SAS 1.1 PHY jitter MJSQ modifications

T10/04-332r0

Date: October 4, 2004
To: T10 Technical Committee
From: Bill Ham (bill.ham@hp.com)
Subject: SAS 1.1 PHY jitter MJSQ modifications

Figure 48 — Eye mask at IR, CR, and XR

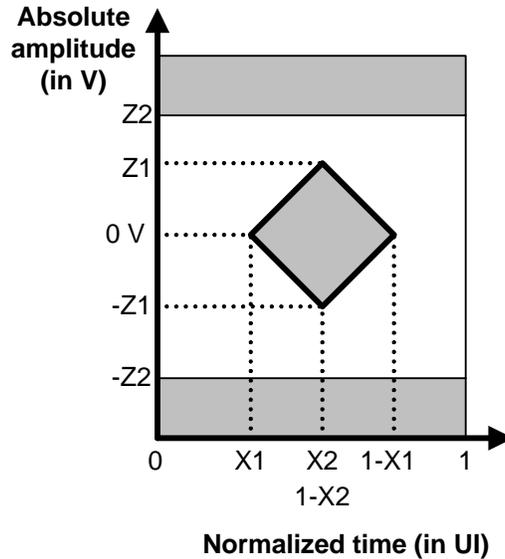
Figure 48 describes the receive eye mask. This eye mask applies to jitter after the application of a single pole high-pass frequency weighting function that progressively attenuates jitter at 20 dB/decade below a frequency of $((\text{bit rate}) / 1667)$

The signal shall be measured using a jitter timing reference, e.g. Golden PLL, that approximates a single pole (20dB / decade) low pass filter with corner frequency of the signaling rate / 1667. This requirement accounts for the low frequency tracking and response time of CDRs in receiver devices.

Figure 49 — Deriving a tolerance mask at IR, CR, or XR

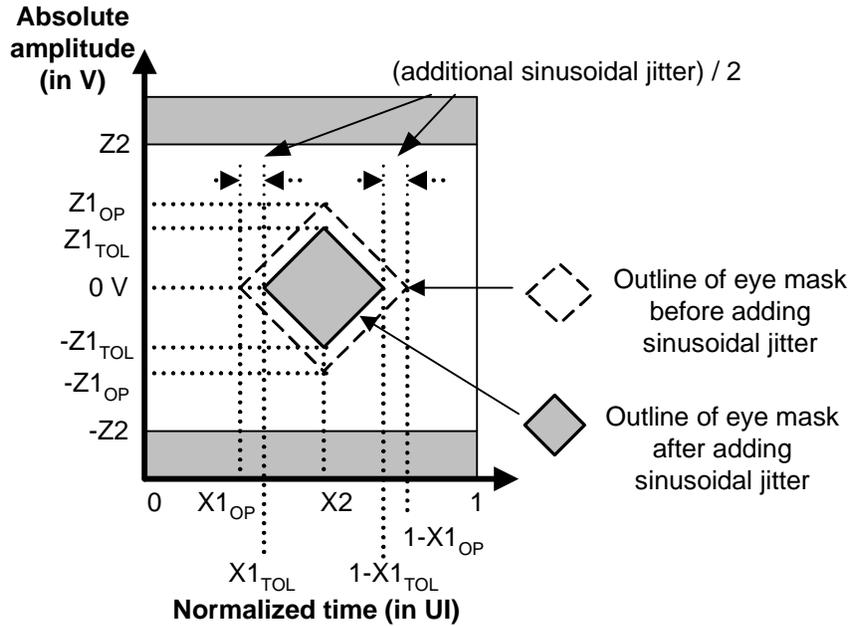
Figure 49 describes the receive tolerance eye masks at IR, CR, and XR and shall be constructed using the X2 and Z2 values given in table 27. X1_{OP} shall be half the value for total jitter in table 28 and X1_{TOL} shall be half the value for total jitter in table 29, for **applied sinusoidal** jitter frequencies above ((bit rate) / 1 667).

Figure 50 — Applied Sinusoidal jitter mask

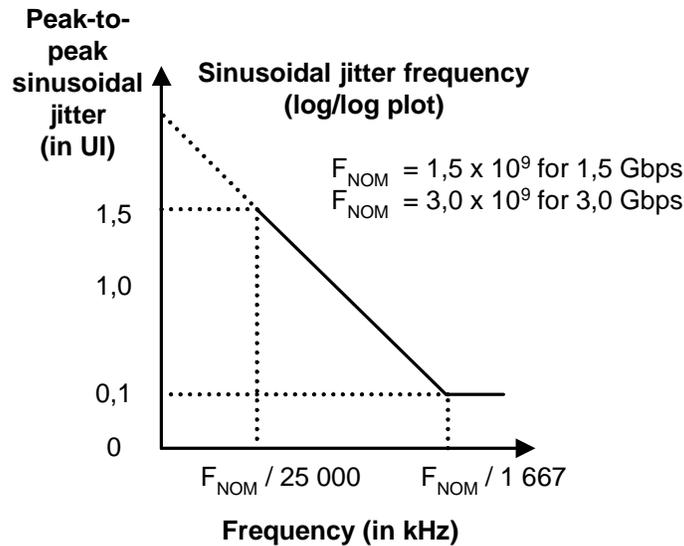
Figure 50 defines the **applied** sinusoidal jitter mask.
